SOLICITATION NUMBER: 2025-41 Chesterfield Storm Sewer Project

Addendum Number: 1

2025-41 Chesterfield Ave. Storm Sewer Hazard Mitigation Grant Project PRE-BID CONFERENCE

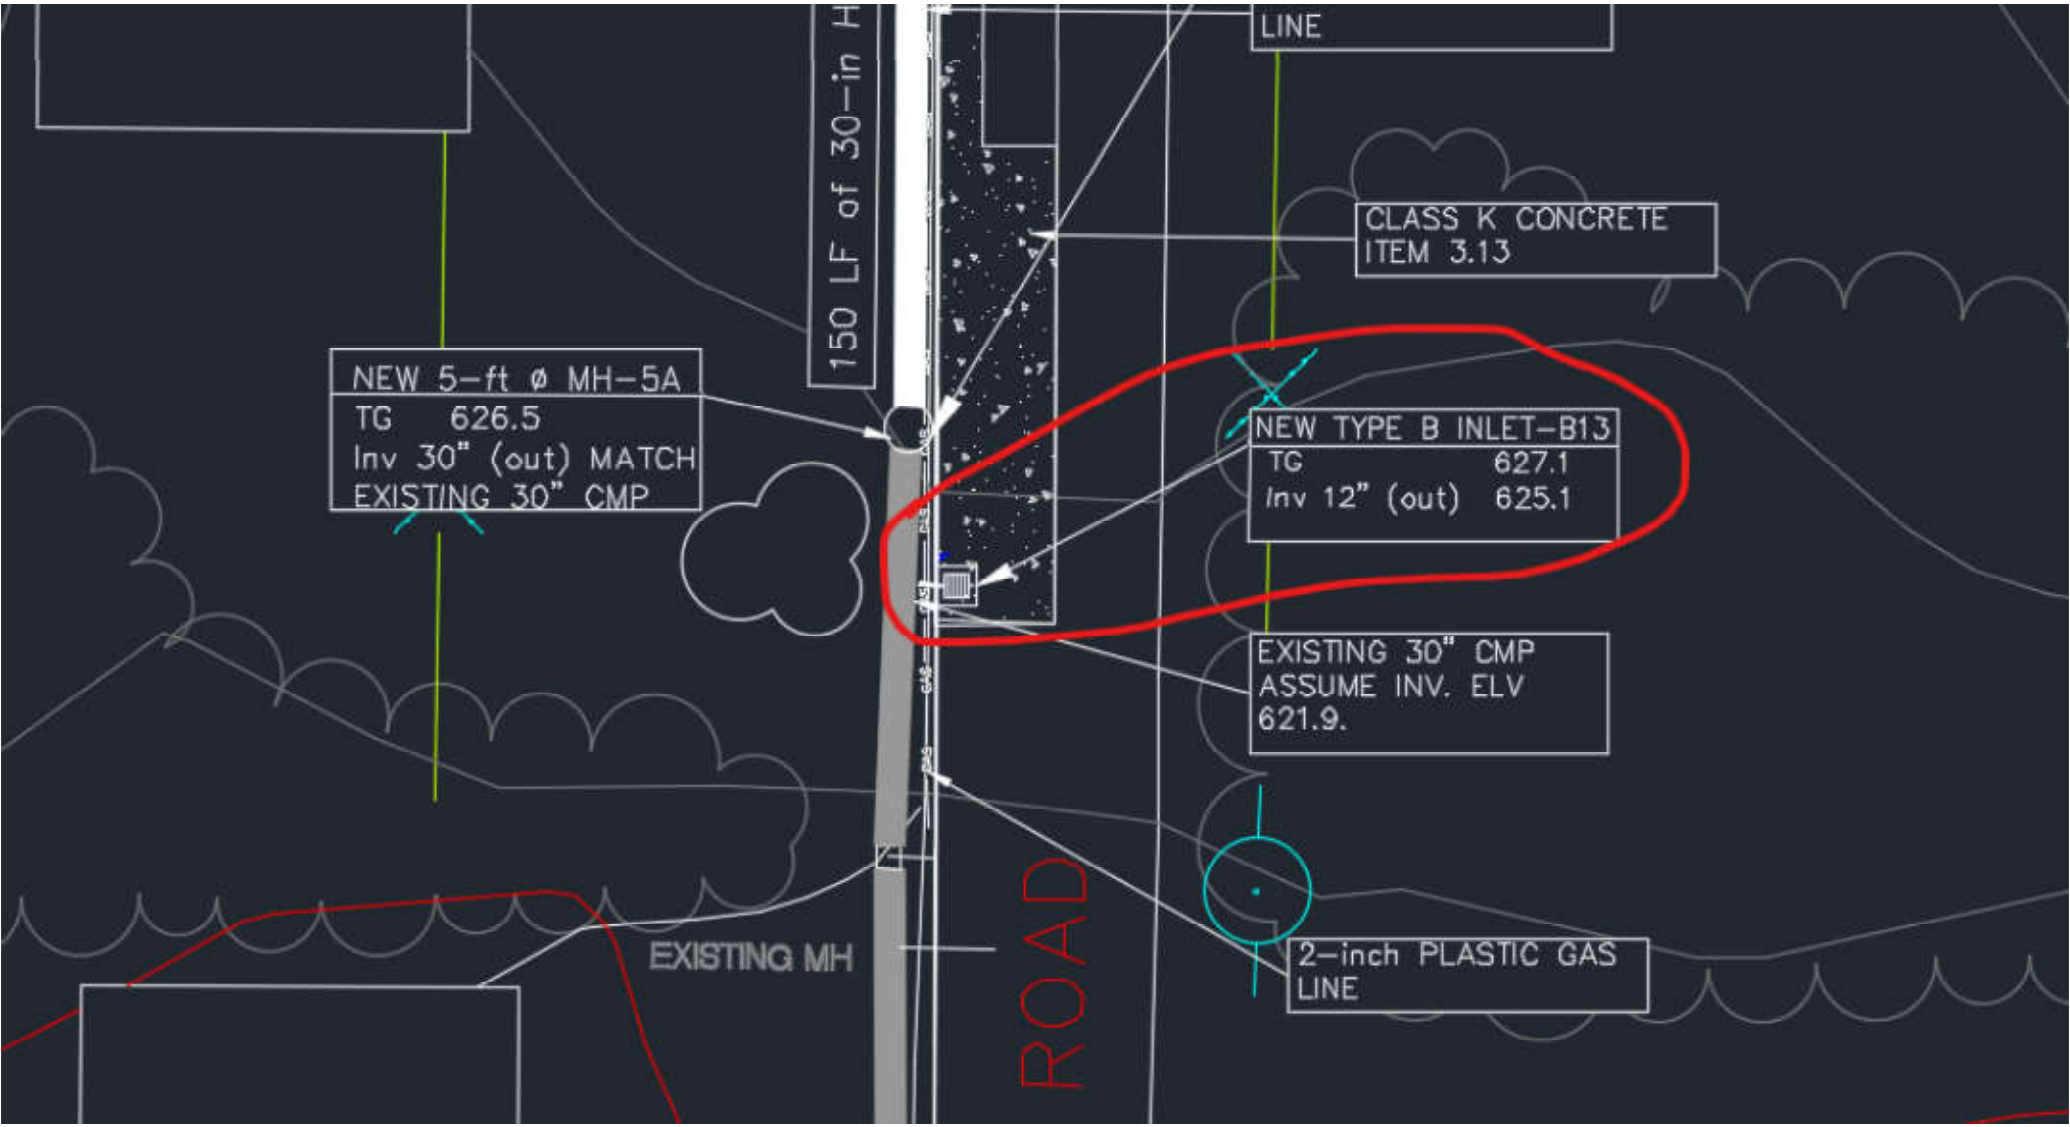
Description of Modification to Solicitation: Addendum 1 is issued to correct the plans that incorrectly show Type B Inlet B13 connecting to the existing 30-inch CMP. Type B Inlet B13 shall be connected to MH-5A or the new 30-inch HDPE. Addendum 1 is also issued to answer vendor questions, attach the pre-bid sign-in sheet, and detail showing the dowel bar and tie bar layout for Item 3.13 Class K Portland Cement Concrete addressed in Vendor Question 10.

Q10: Can the City provide a detail showing the dowel bar and tie bar layout for Item 3.13 Class K Portland Cement Concrete.

A10: Detail attached.

NEW 5-ft ϕ MH-5A
TG 626.5
Inv 30" (out) MATCH
EXISTING 30" CMP

NEW TYPE B INLET-B13
TG 627.1
Inv 12" (out) 625.1

EXISTING 30" CMP
ASSUME INV. ELV
621.9.
